DEVELOPMENT CONSENT AUTHORITY
TENNANT CREEK DIVISION

AGENDA ITEM: **1** MEETING DATE: 17/02/2025 FILE: PA2024/0282

APPLICATION: Dwelling – group comprising of x 1 existing single storey dwelling and 2 x 3 bedroom 1 x two storey buildings
APPLICANT/CONTACT: Mary Kingham Bradley
LAND OWNER: Mary Kingham Bradley and Christopher Richards
LOCATION: (73) Ambrose Street, Tennant Creek (**Bookmark A**)
ZONE: LMR (Low Medium Density Residential)
AREA: 715m²

Site Plan

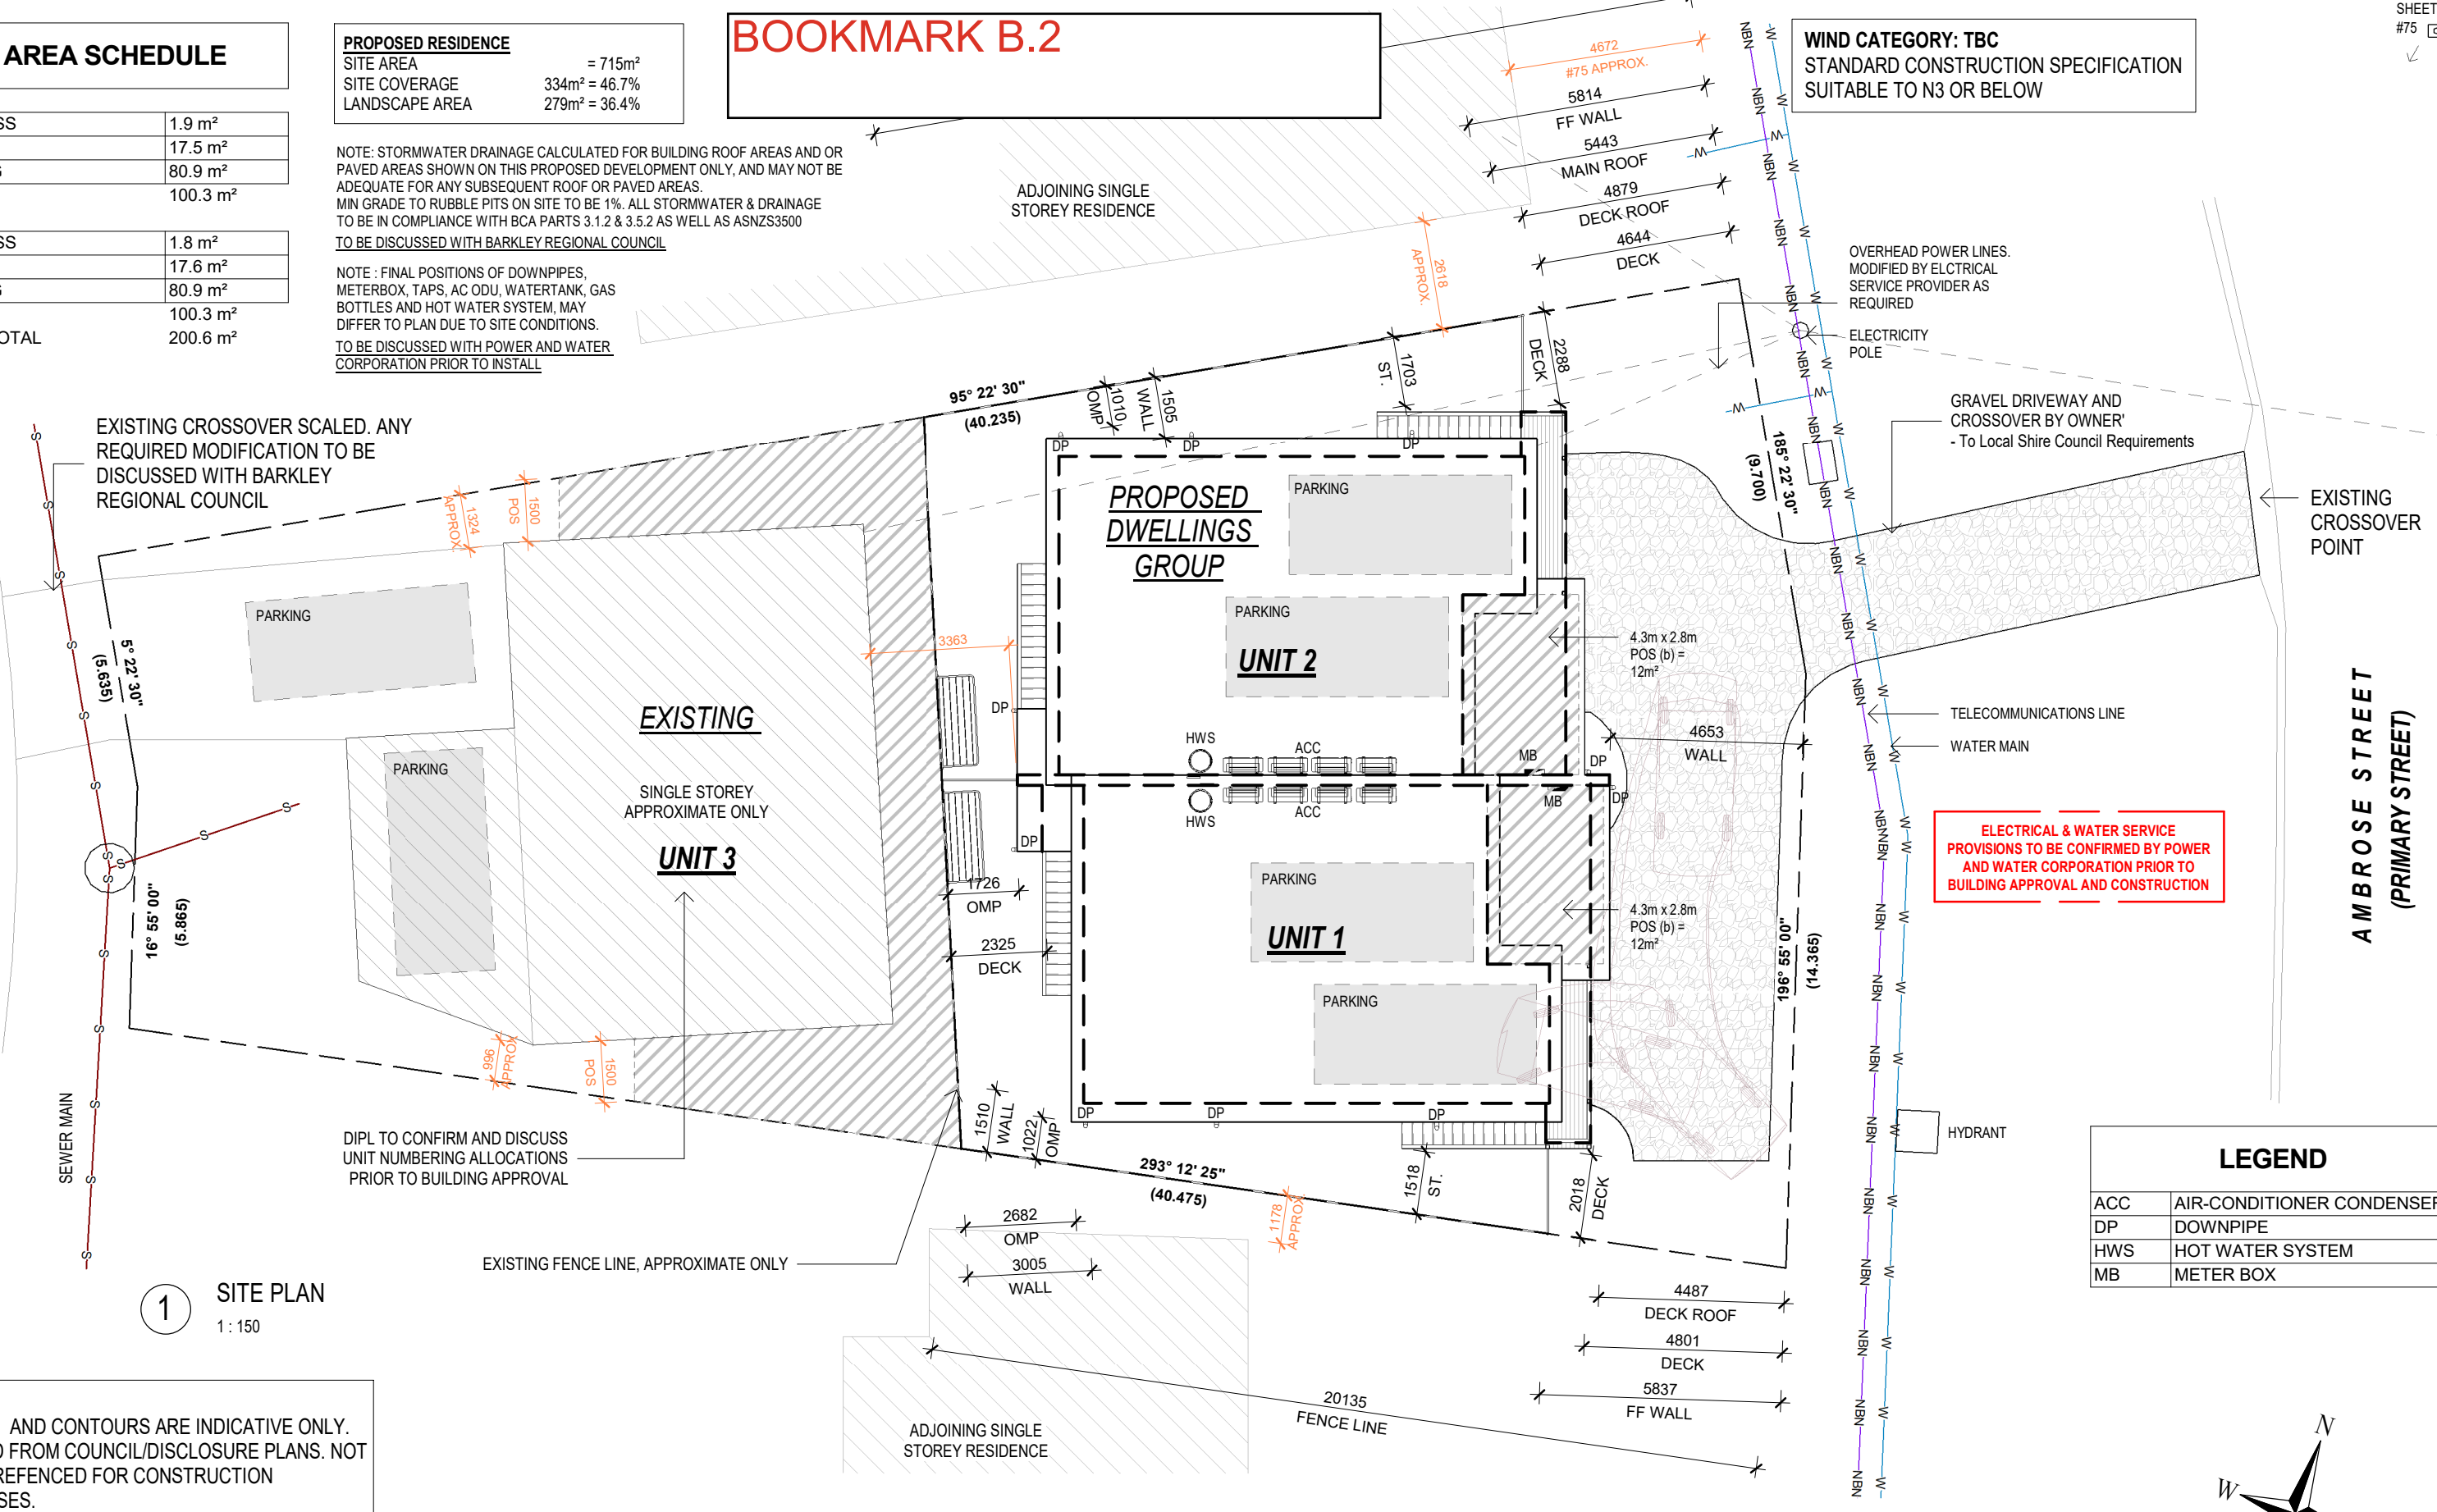
Table A outlines that the development of a residential building is required to provide a 6m building setback from the primary street boundary. The development does not comply because unit 1 will result in a building setback shortfall of 5.8m (from its wall to the front boundary).

The existing dwelling on Lot 171 does not comply with Table A to Clause 5.4.3 because the development of a residential building is required to provide a building setback of 1.5m (the existing building sits 1m off the side boundary adjoining Lot 2156).

Landscape & Area Plan

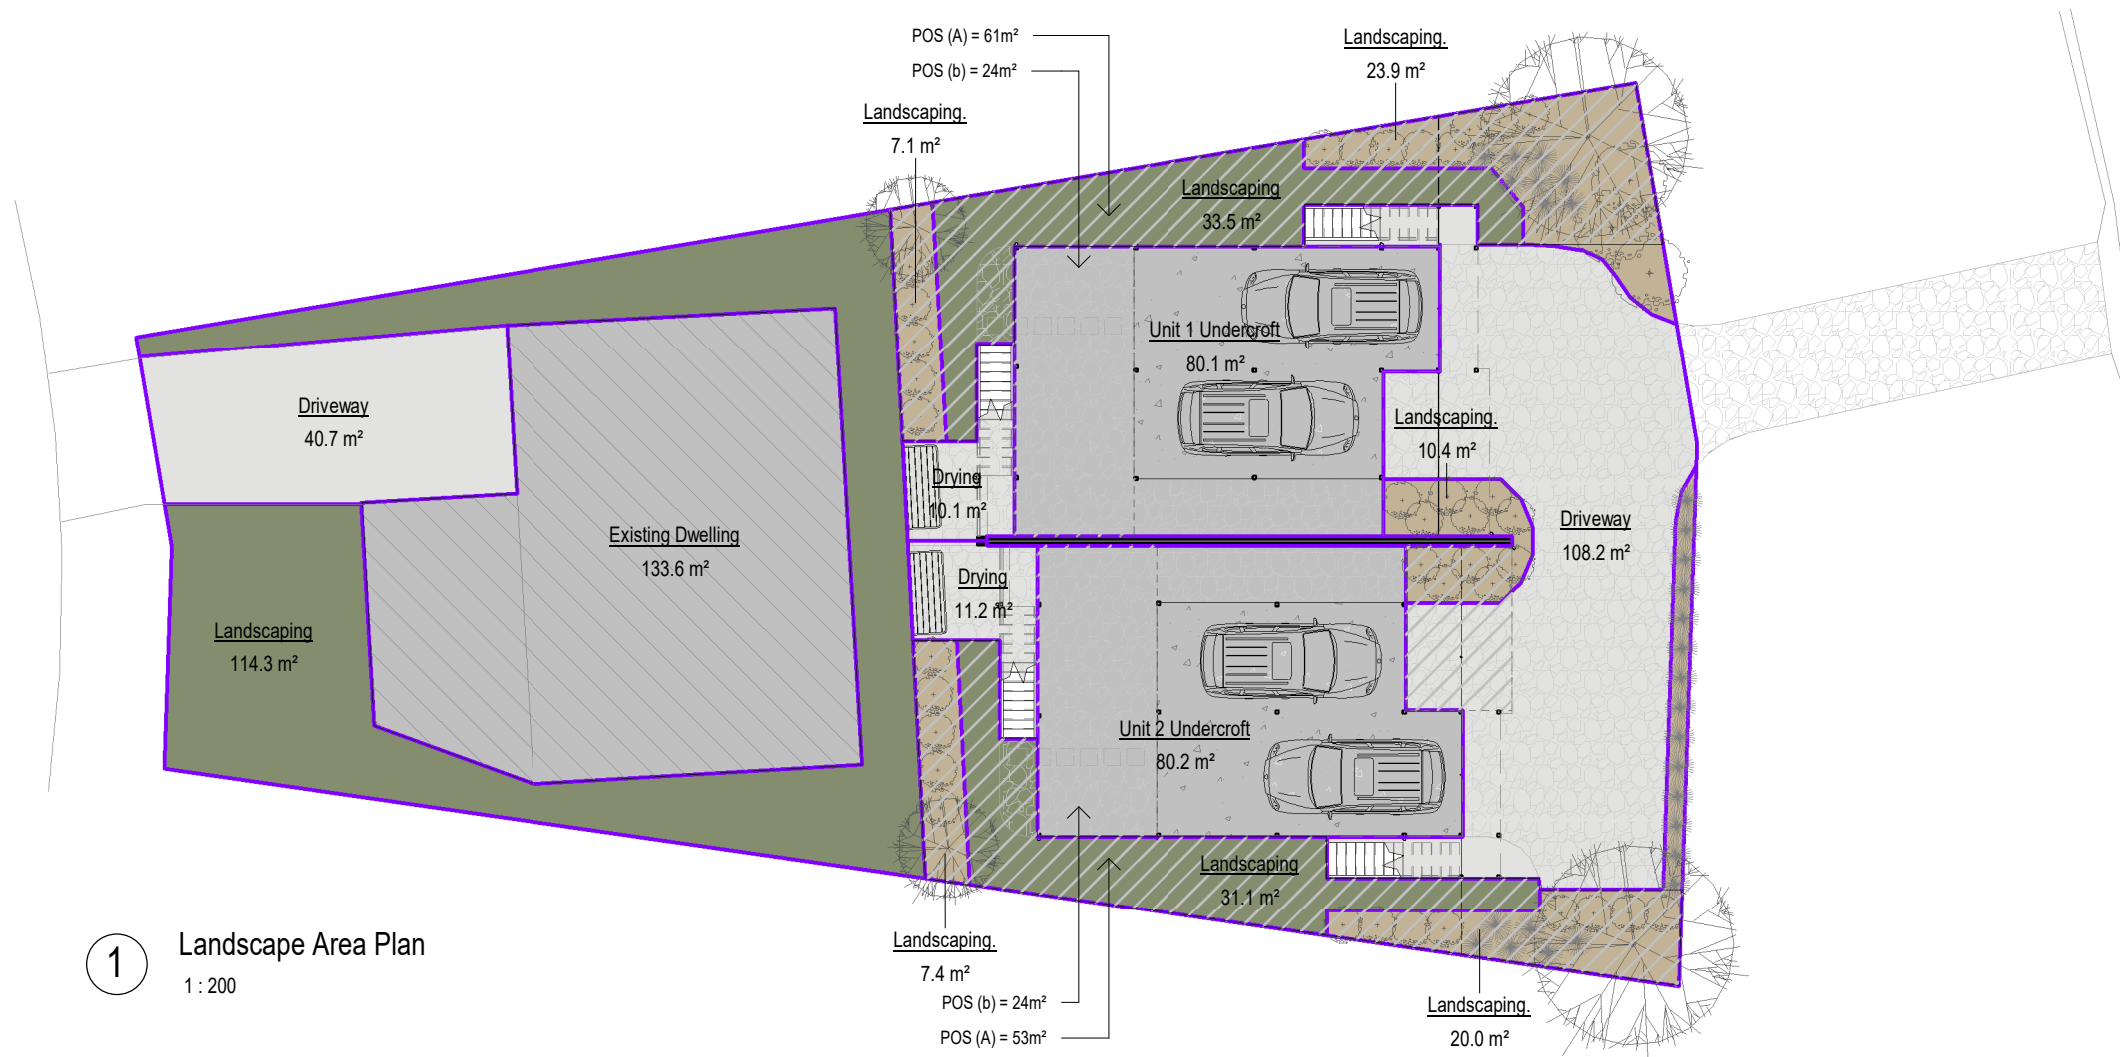
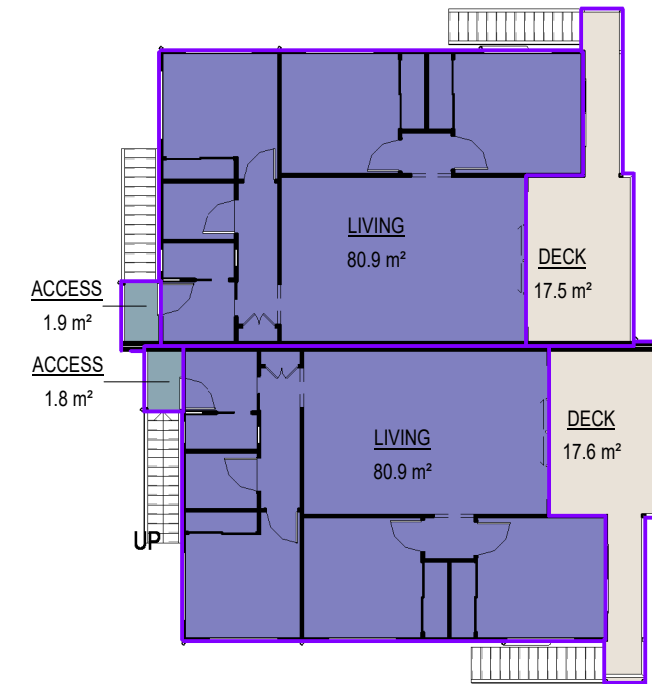
With regards to sub clause (3) of Clause 5.2.6.1, the development proposal does not detail the layout and choice of plants or how they will be maintained for the life of the development.

Sub clause (5) of Clause 5.2.6.1 requires 30% of the lot to be landscaped. Lot 171 totals 715m² meaning 214.5m² of the lot to be landscaped. It has been estimated that the proposed development will provide around 225m² of landscaped area.

BOOKMARK B.4

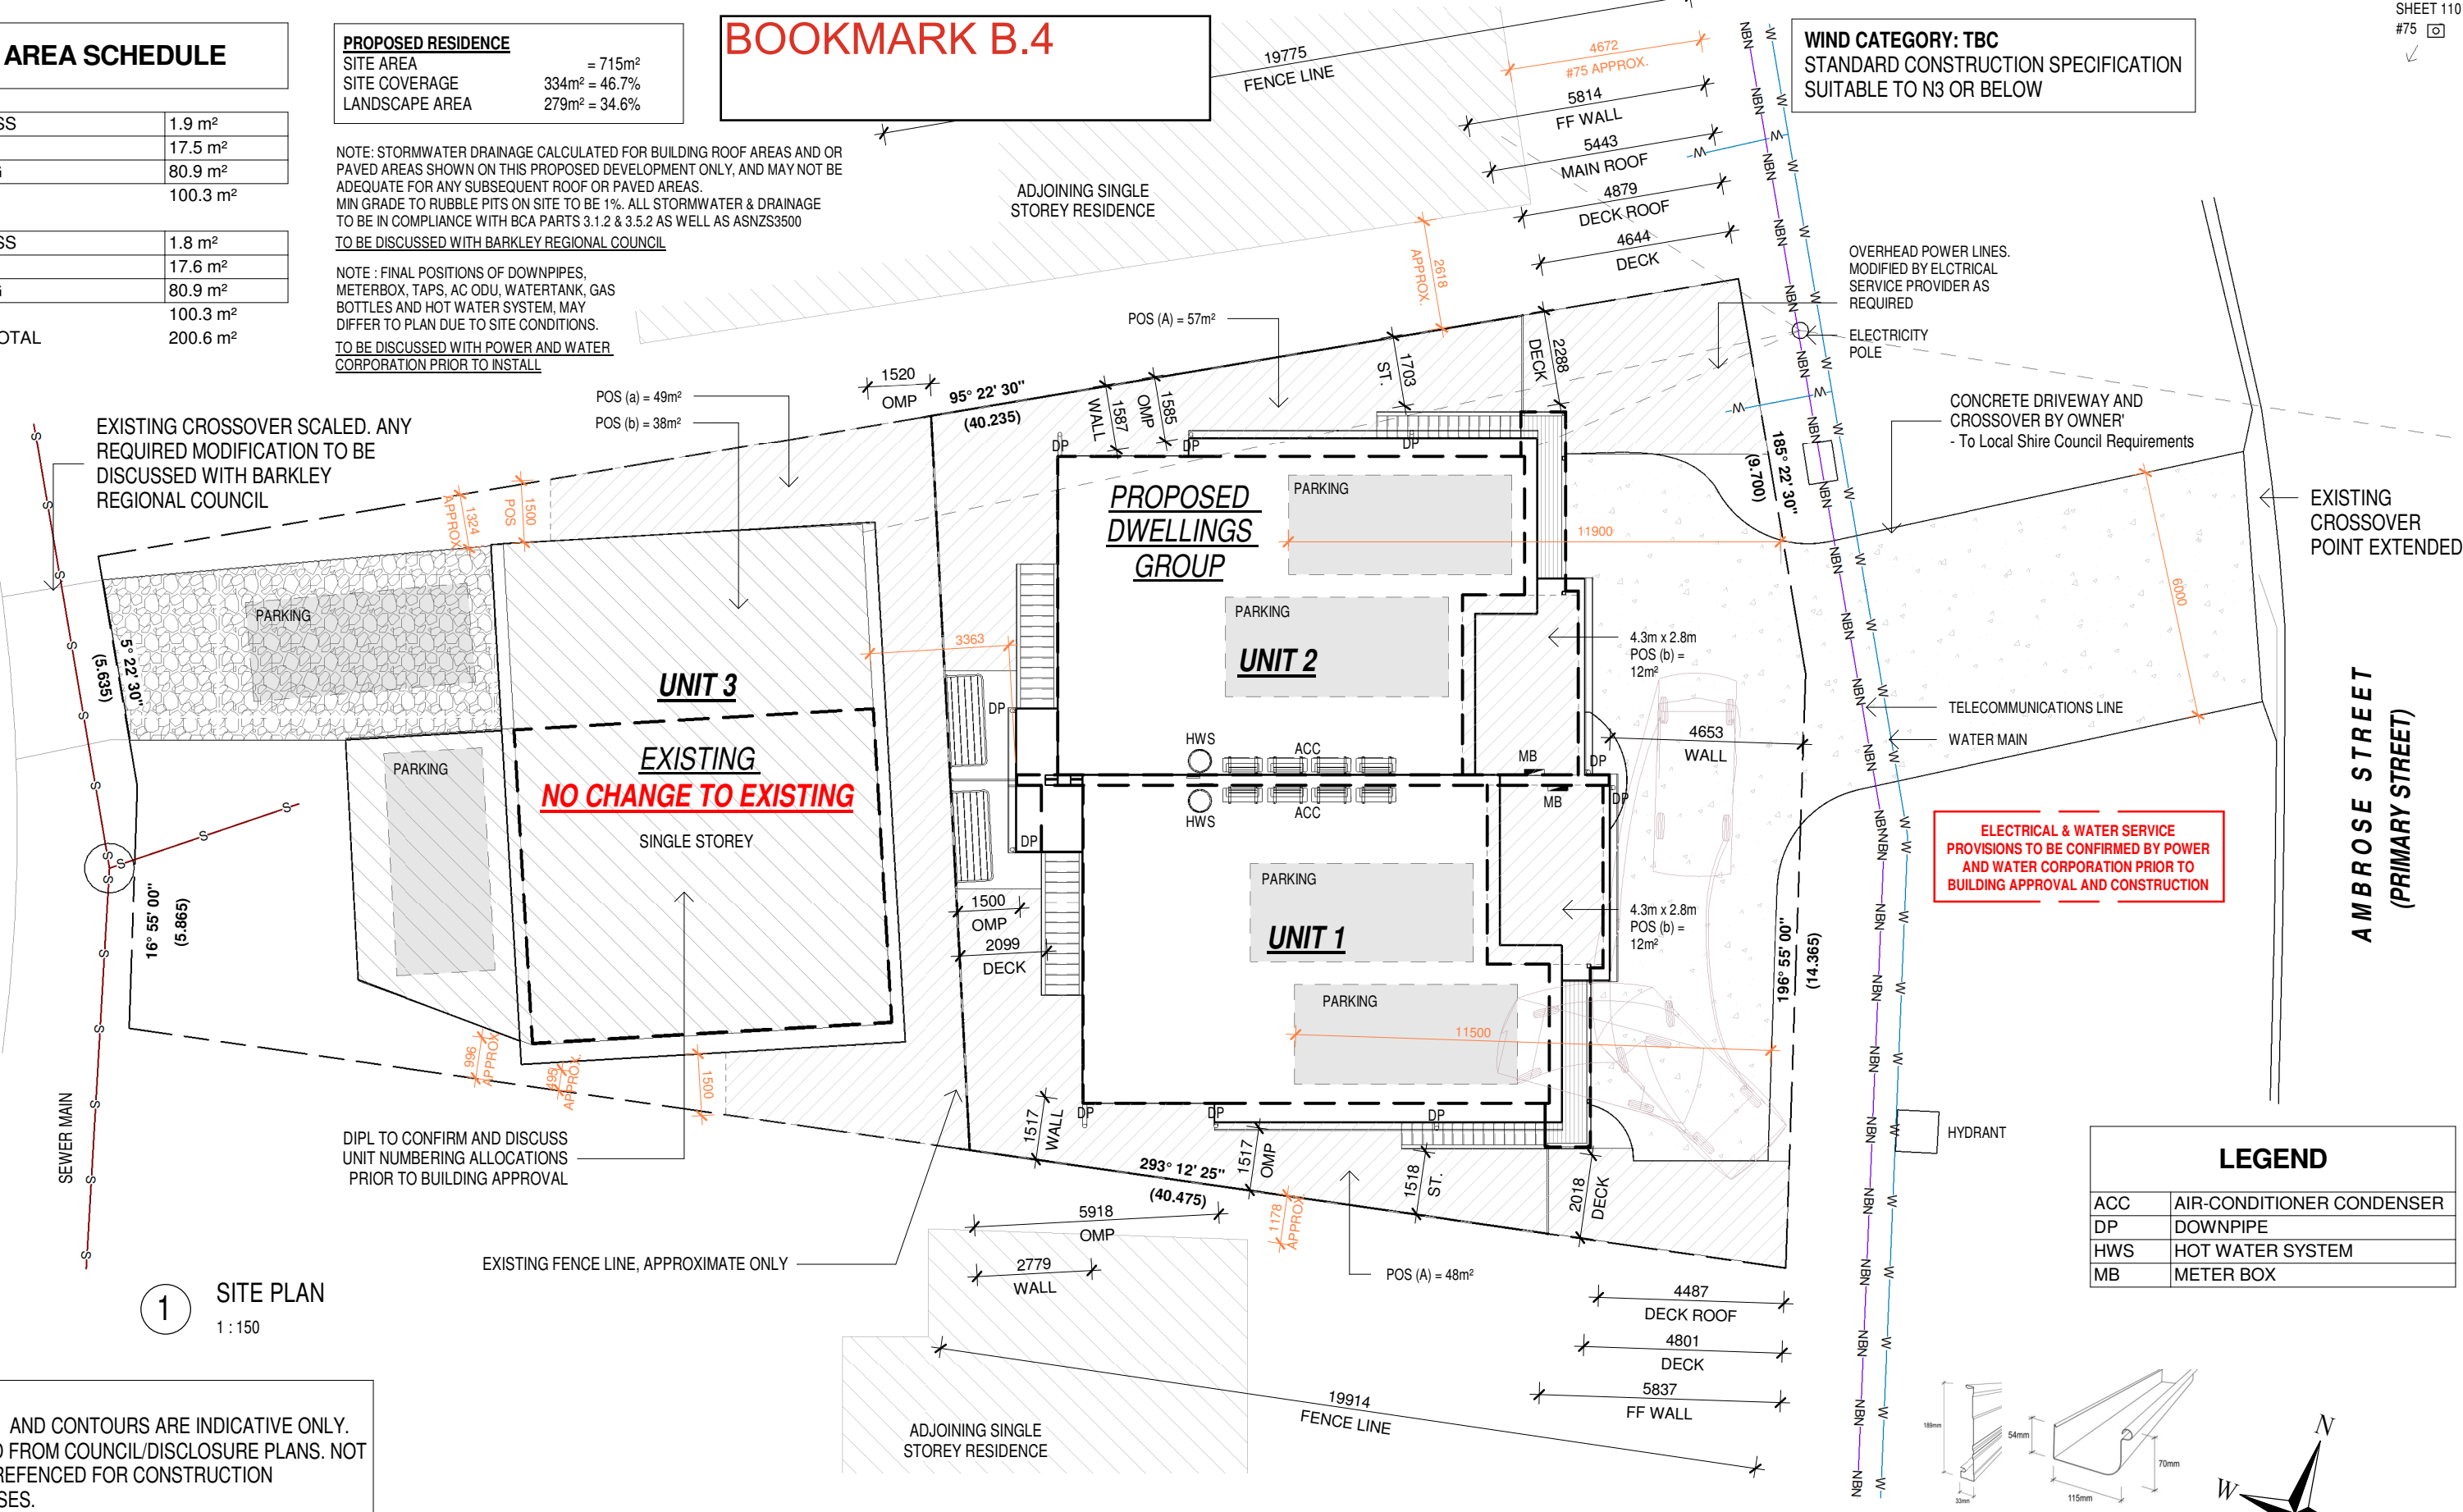
Table A outlines that the development of a residential building is required to provide a 6m building setback from the primary street boundary. The development does not comply because unit 1 will result in a building setback shortfall of 200mm (from its wall to the front boundary).

The existing dwelling on Lot 171 does not comply with Table A to Clause 5.4.3 because the development of a residential building is required to provide a building setback of 1.5m (the existing building sits 1m off the side boundary adjoining Lot 2156).

Required building setback Clause 5.4.3	DAS/DLPE comment	Compliance
Primary Street boundary	4.6m for the ancillary verandahs 6.10m dwellings	COMPLIES
Secondary Street boundary	Exceeds 9m from the rear laneway	COMPLIES
Side boundaries	1m at its closest point for unit 2 adjoining Lot 170 2.25m for verandah / deck for unit 2 adjoining Lot 170	1.5m side building setback required for Unit 2 DOES NOT COMPLY
	1m at its closest point for unit 1 adjoining Lot 2156 2.10m for verandah/deck for unit 1 adjoining Lot 2156	1.5m side building setback required for Unit 1 DOES NOT COMPLY
